Access Compliance Report Public Rights-of-Way (Curb Ramps)

Main Street: NORWOOD_PKWY Cross Street: HOLT_AVE Location: SW

ADA ID: RPAT211004133453 Ramp Type: Type 7 - Directional 2 Initial Pass/Fail: Fail Overall Compliance: No Severity Score: 2

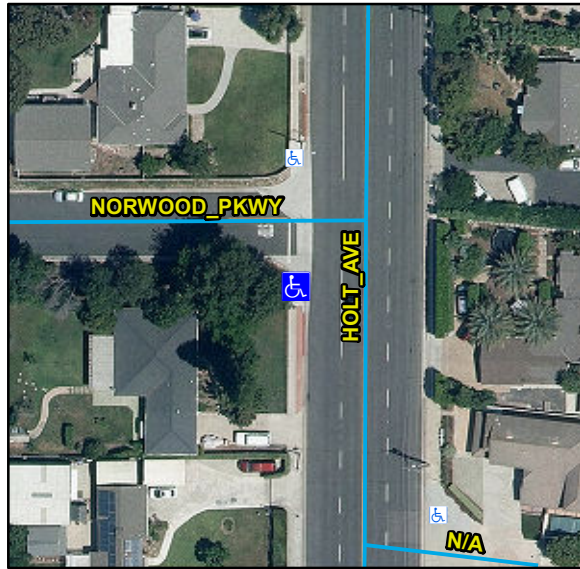
Compliance	Description	Data	Compliance	Description	Data
N/A	Ramp Length (in)	101	N/A	Flare Type LT	
Yes	Ramp Width (in)	48			N/A
Yes	Ramp Run Slope (%)	7.6	N/A	Flare Slope LT (%)	N/A
No	Ramp Cross Slope (%)	2.2	N/A	Flare Traversable LT	N/A
N/A	Grade Break	N/A	N/A	Flare Type RT	
N/A	Grade Break Slope (%)	N/A			N/A
N/A	Grade Break Cross Slope (%)	N/A	N/A	Flare Slope RT (%)	N/A
	Addl Para Ramp Left?	No	N/A	Flare Traversable RT	N/A
	Addl Para Ramp Right?	No	N/A	DWS Provided	N/A
N/A	Landing Present	N/A	N/A	DWS Contrast	N/A
N/A	Landing Length (in)	N/A	N/A	DWS Length (in)	N/A
N/A	Landing Width (in)	N/A	N/A	DWS Full Width	N/A
N/A	Landing Run Slope (%)	N/A		DWS Offset Type	N/A
N/A	Landing Cross Slope (%)	N/A	N/A	DWS Left Offset (in)	N/A
N/A	Landing Movement Obstructed?	N/A	N/A	DWS Right Offset (in)	N/A
	Landing Movement Type	N/A			
N/A	Landing Shared	N/A			
N/A	Marked Crosswalk 1	No	N/A	Clear Space	N/A
	Crossing 1 Direction	N	N/A	Clear Space To Crosswalk (in)	N/A

Remove & Replace Entire Ramp. Replace Spandrel.

R304.5.3, STD 122-2, STD 1115
